**3 Aldred Road  
London NW6 1AN**

**Basement Impact Assessment  
Audit**

London Borough of Camden

Project Number: 12066-60  
Revision: F1

506\_SK\_002

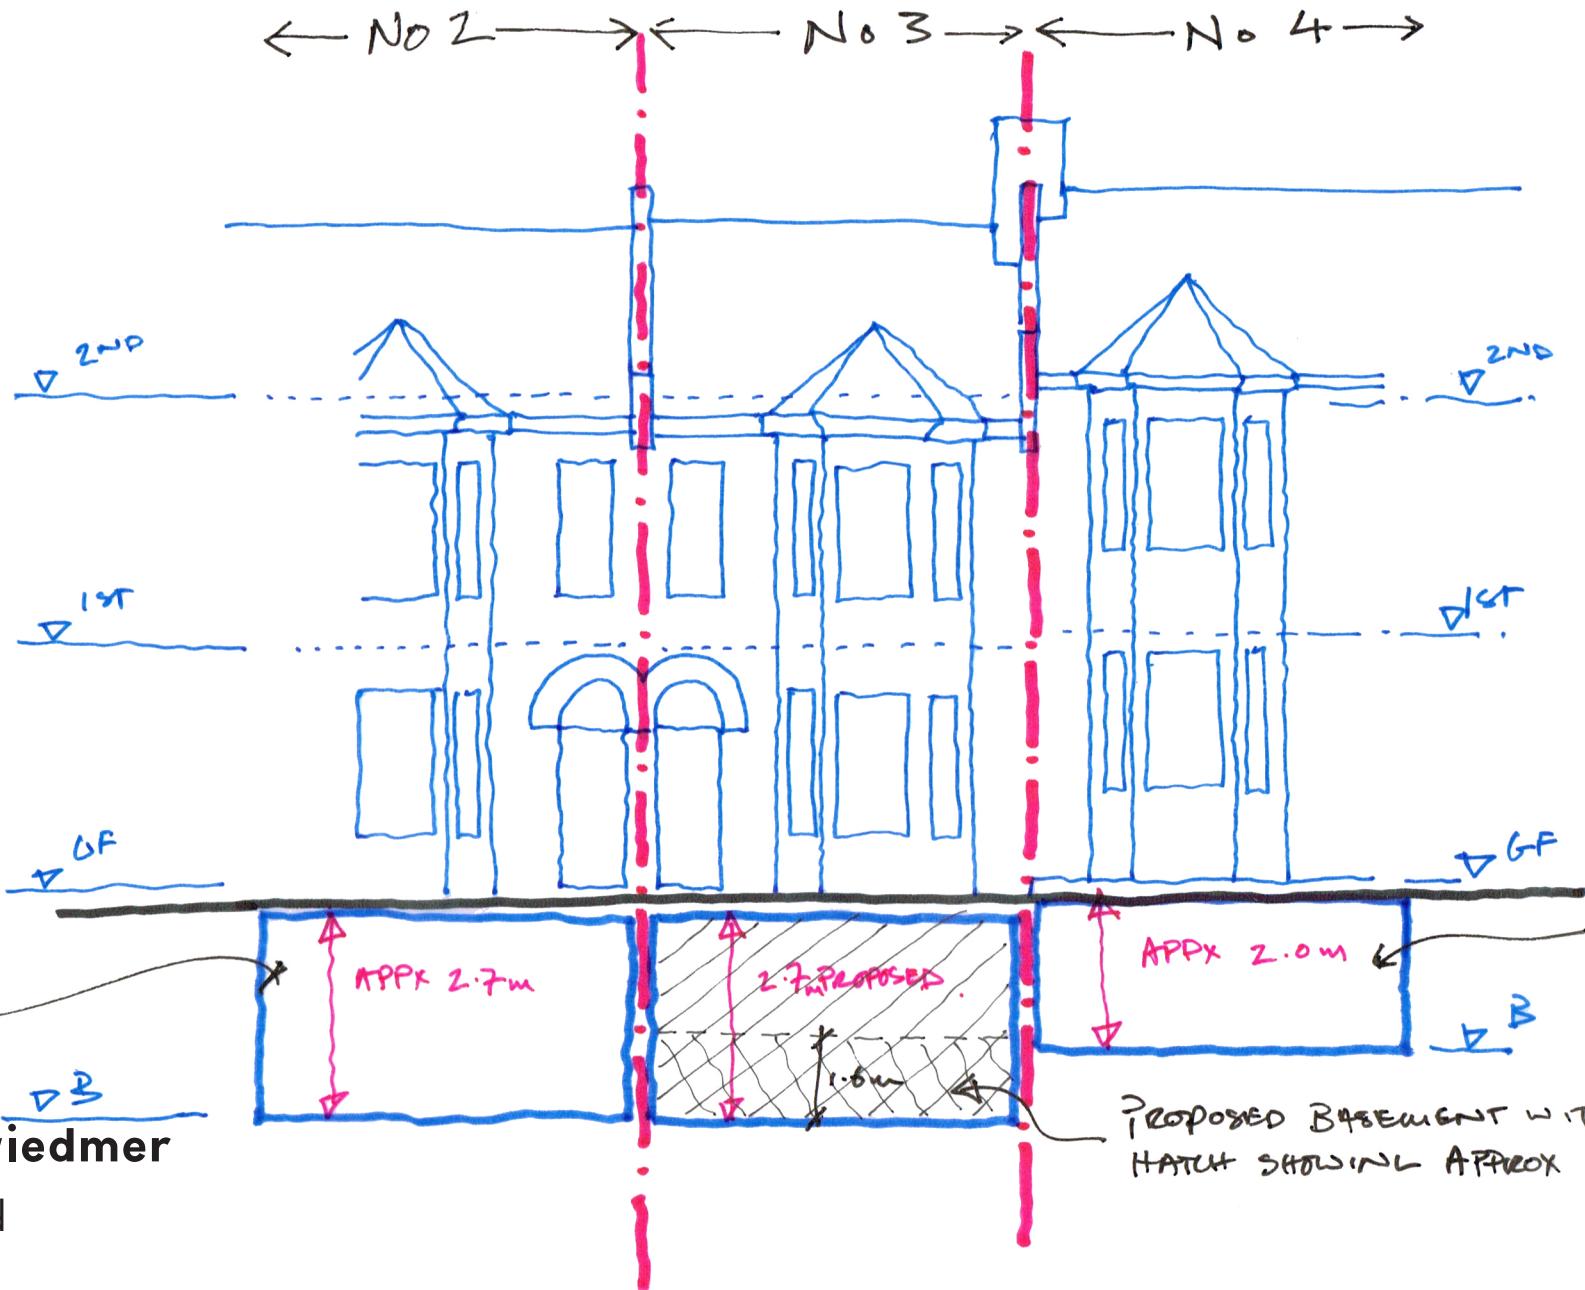
9	Stability	No information has been supplied on the presence or otherwise of adjacent basements. This information should be provided.	Open.	29/02/16

Following enquiries with adjacent owners we note the presence of basements or undercrofts to both neighboring properties as illustrated in the attached sketch (501\_SK\_002). We understand No 4 has the same undercroft as No3, a shallow basement with head height of approximately 2m. No 2 has a full depth basement under the full footprint of the building with a front light well onto the street. The presence of these basements should reduce CR's concern regarding deepening the existing foundations affecting how the building behaves and will reduce the differential ground movement and strains in item 6 above. (501\_SK\_002\_Adjoining Basements)

Sketch showing presence and estimated depth of adjacent basements to No 3 Aldred Road
